Service Bulletin N° 98

Addition of Reset Alignment Bracket Kit Part N° 500-6210-00.

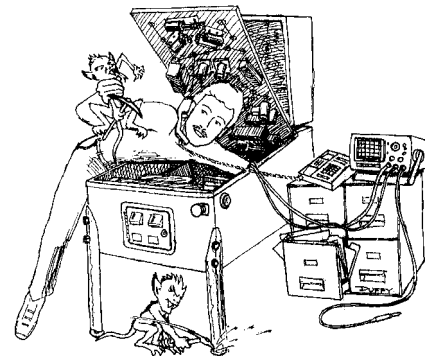
Drop Targets intermittently stick in the "Up Position." Game vibration normally will free them.

The Drop Target Lift Bracket on occasion will turn & bind in the Target Support Brackets. Lubricating the side flanges that guide the Lift Bracket Up and Down will correct this problem. We recommend using White Lithium Grease or a "dry" lubricant such as Teflon Spray. **To ensure a maintenance free assembly we have added alignment brackets to all current assemblies which act as a backplate thus limiting the left & right movement of the Lift Bracket (this eliminates the need for lubrication).** Using the *Reset Alignment Bracket Kit (containing: Reset Alignment Brackets, 535-8065-00, 2 Ea. and #8-32 Keps Nut, 240-5104-00, 4 Ea.)* follow the simple procedure below in lieu of lubrication.

Attach one (1) Reset Align. Bracket **on each side** over the existing two (2) #8-32 Mounting Screws securing the Height Adj. Bracket. Secure the new brackets **on each side** with #8-32 Keps Nuts (1 per existing screw).
